**HORIZONTAL DIRECTIONAL DRILL ANALYSIS
WOODBINE DRIVE CROSSING
PADEP SECTION 105 PERMIT NO.: E22-617
PA-DA-0063.0000-RD-16
(SPLP HDD No. S3-0081-16)**

This reevaluation of the horizontal directional drill (HDD) installation of a 16-inch diameter pipeline that traverses Woodbine Drive and Primrose Drive in Conewago Township, Dauphin County, Pennsylvania, is in accordance with Condition No. 3 of the Stipulated Order issued under Environmental Hearing Board Docket No. 2017-009-L. Condition No. 3 stipulates, for HDDs initiated after the temporary injunction issued by the Pennsylvania Department of Environmental Protection (PADEP) Environmental Hearing Board on July 25, 2017, a reevaluation must be performed on HDDs for which an inadvertent return (IR) occurs during the installation of one pipe (20-inch or 16-inch diameter) where a second pipe will thereafter be installed in the same right-of-way (ROW).

Re: Sunoco PA Pipeline Project Mariner
East II, Woodbine Drive HDD
S3-0081, PA-DA-0063.0000-RD-16
Hydrogeologic Re-Evaluation Report
for 16-Inch Pipeline
Conewago Township, Dauphin
County, Pennsylvania
Rettew Project No. 096302011

Figure 2. Redesigned 16-Inch HDD Plan and Profile

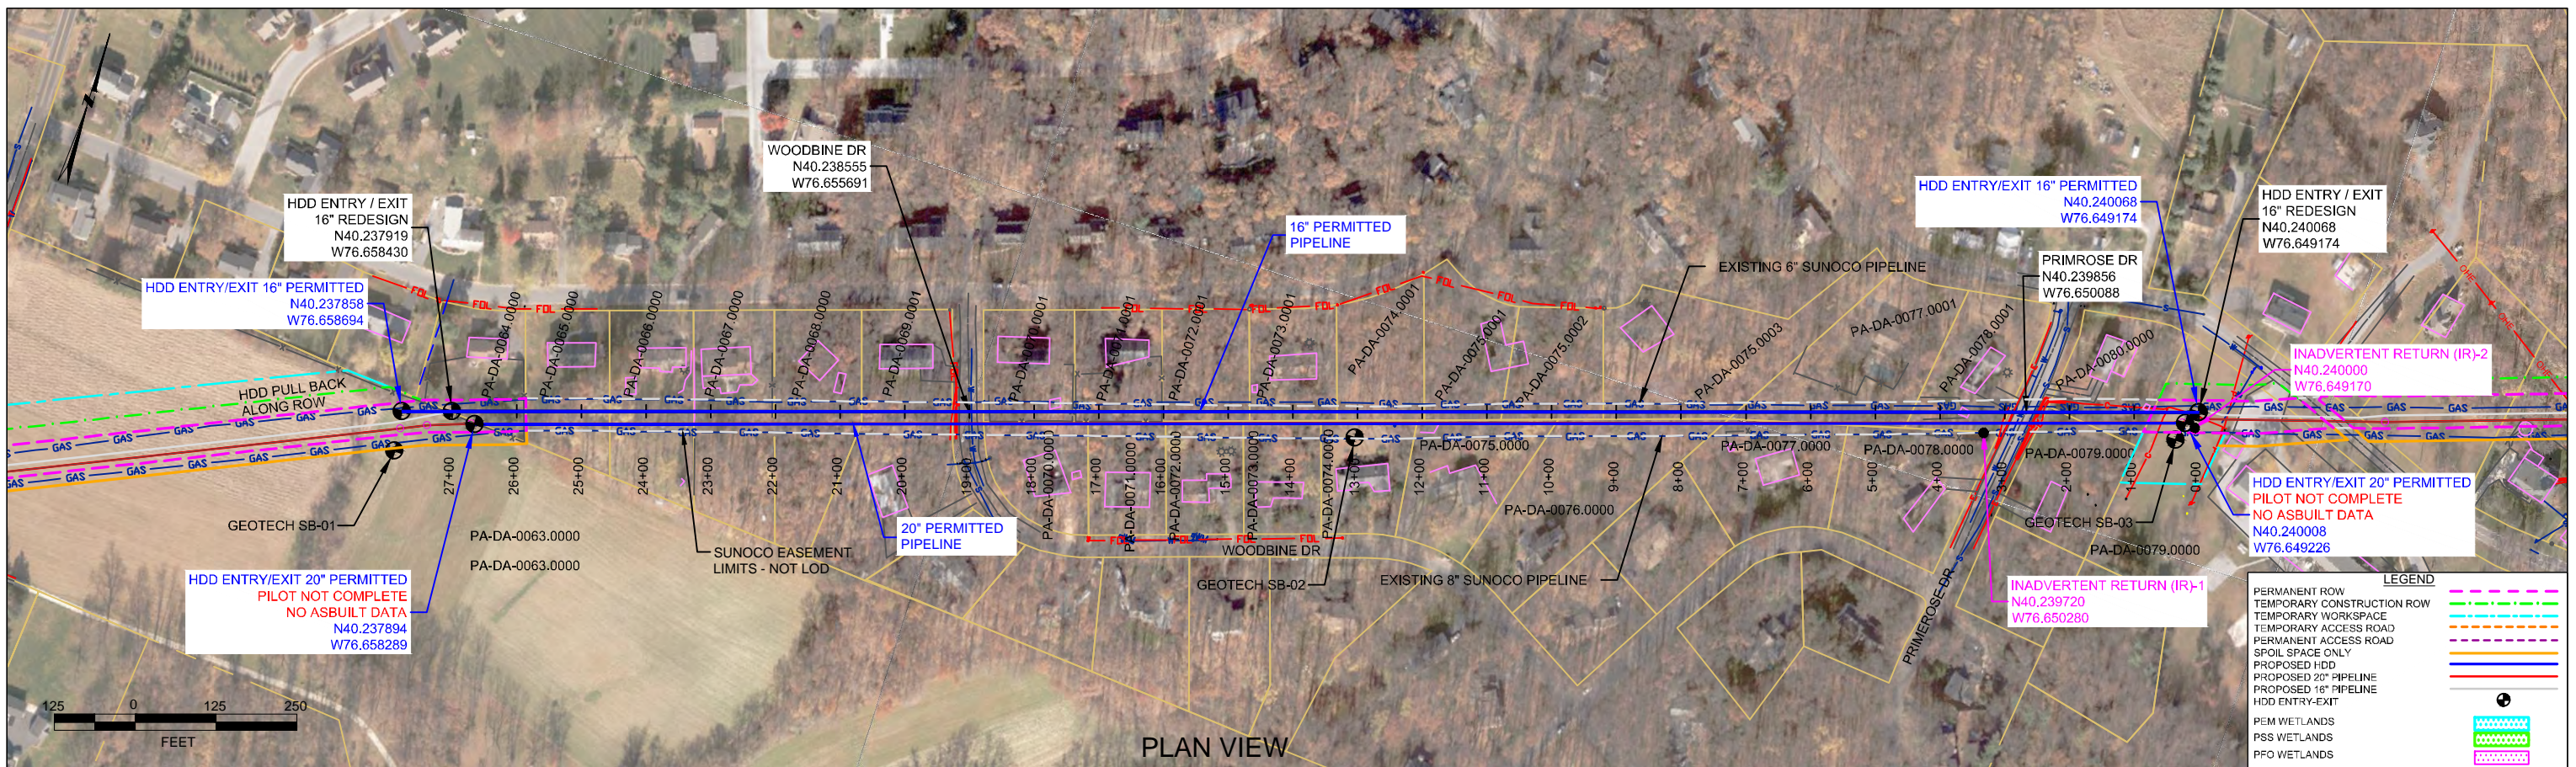
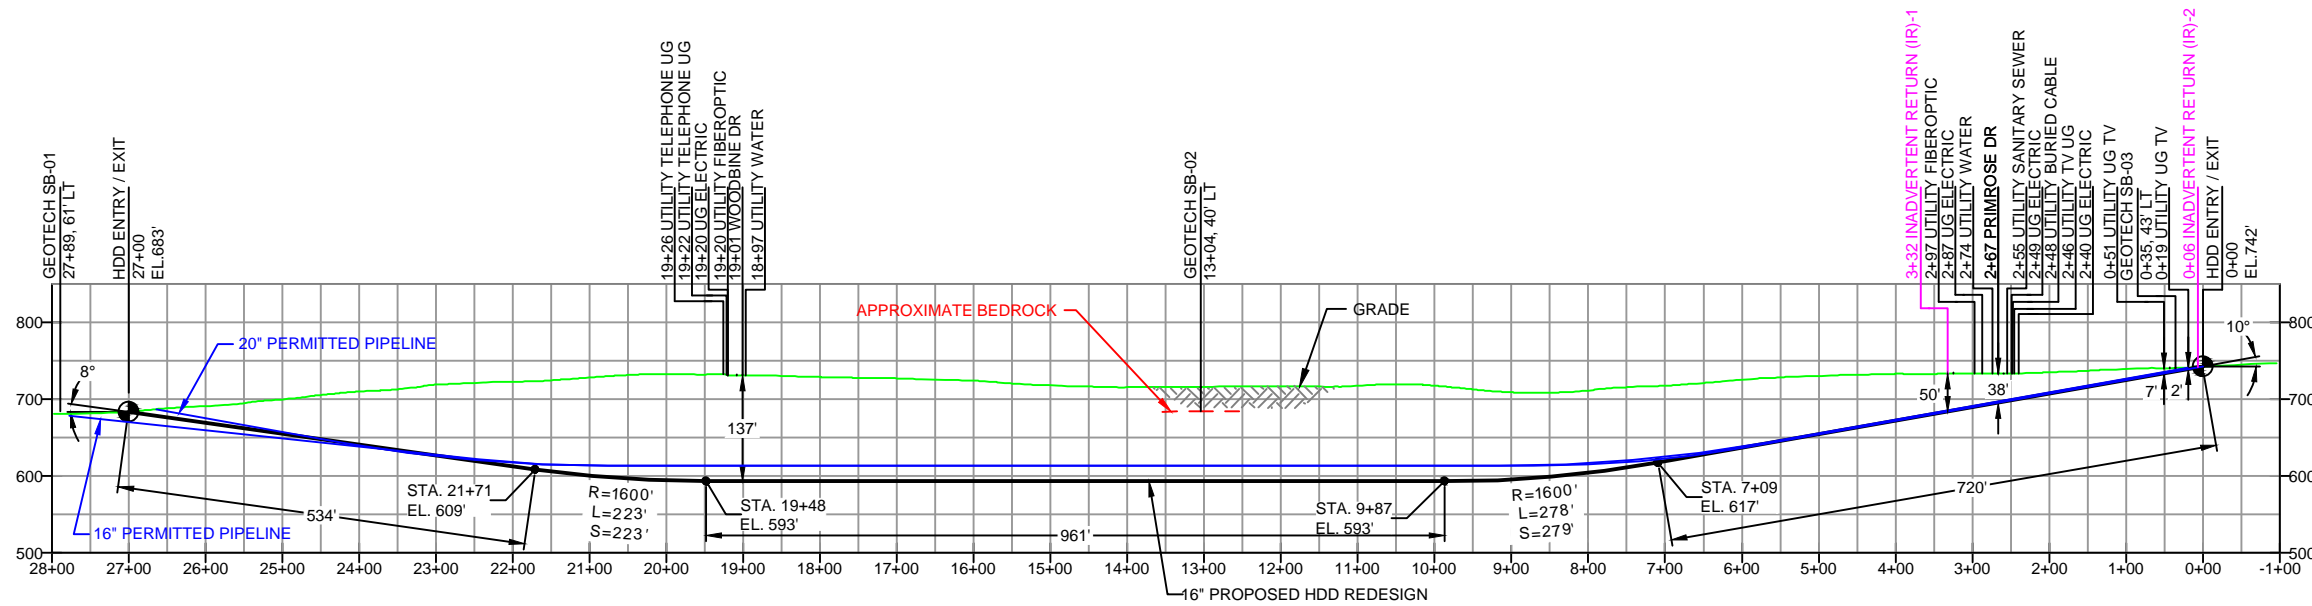
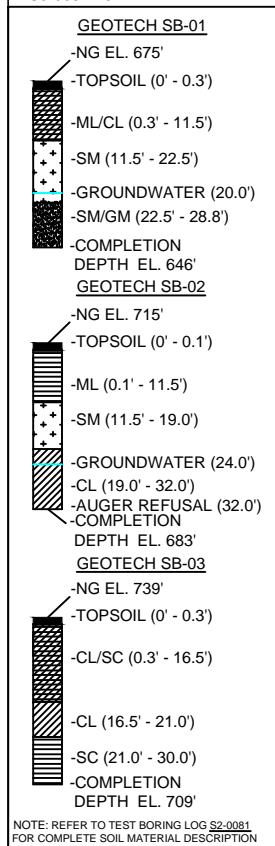
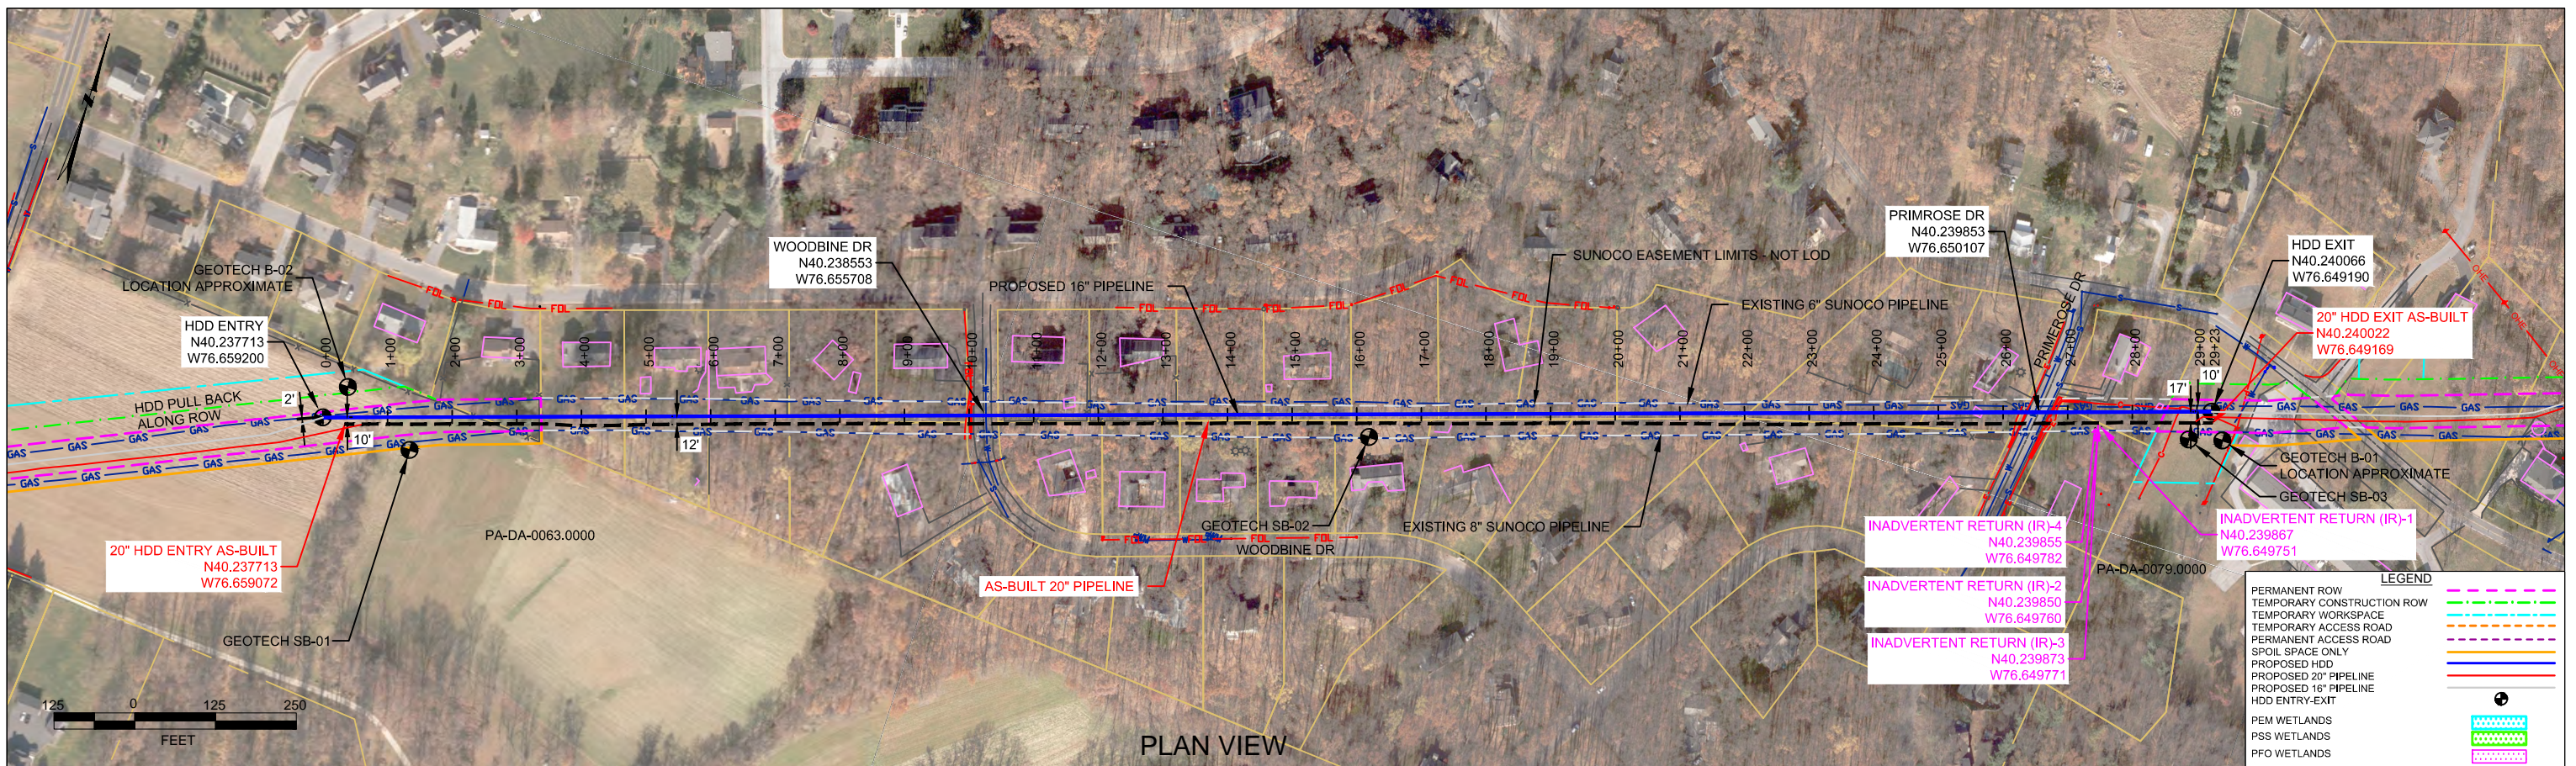
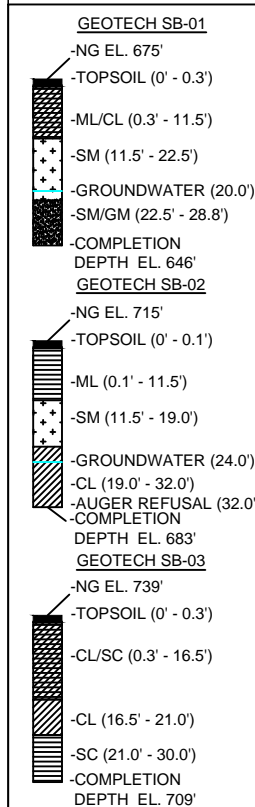
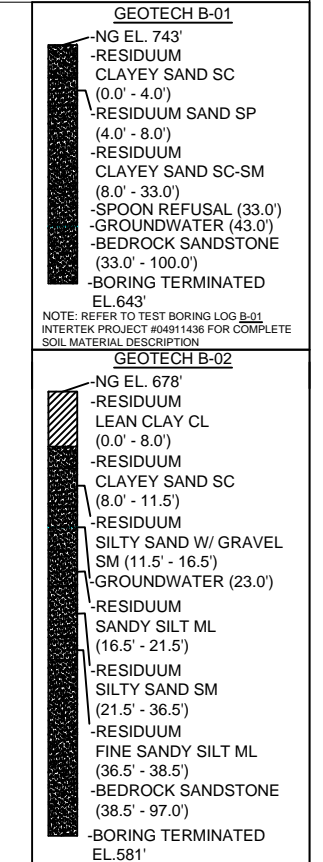
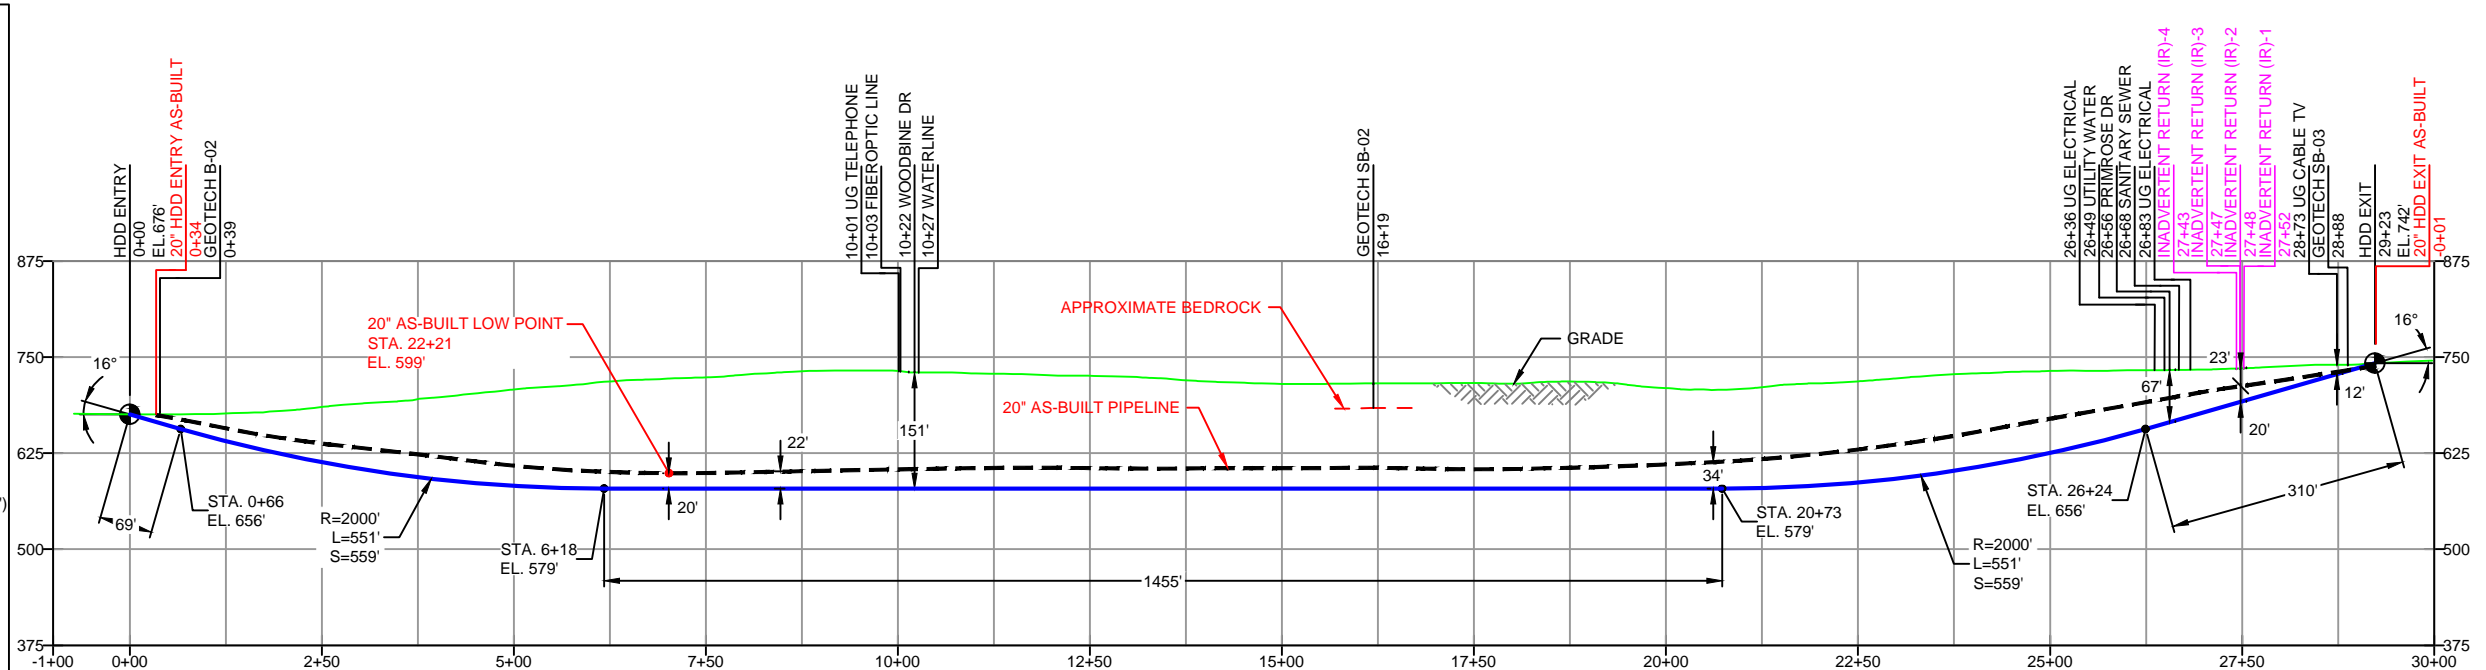
Additional geologic investigations have been completed, and the "as built" record for the 20-inch pipeline has been utilized in the redesign of the planned 16-inch HDD. The redesign adjusts the HDD profile deeper to minimize the risk of drilling fluid loss, drilling difficulties, and IRs. A summary of the redesign factors is provided below. The original and redesigned 16-inch HDD plan and profile drawings are provided in Attachment 2.

- Horizontal length: 2,923 feet
- Entry/Exit angle: 16 degrees
- Maximum depth of cover: 151 feet
- Pipe design radius: 2,000 feet

As shown on Figure 2 in Attachment 2, the redesigned HDD profile for the 16-inch pipeline is deeper, with a maximum depth of cover increased by approximately 24 ft from the permitted design and the entry and exit angles increased to rapidly proceed into and exit out of the bedrock. These adjustments reduce the risk of IRs.
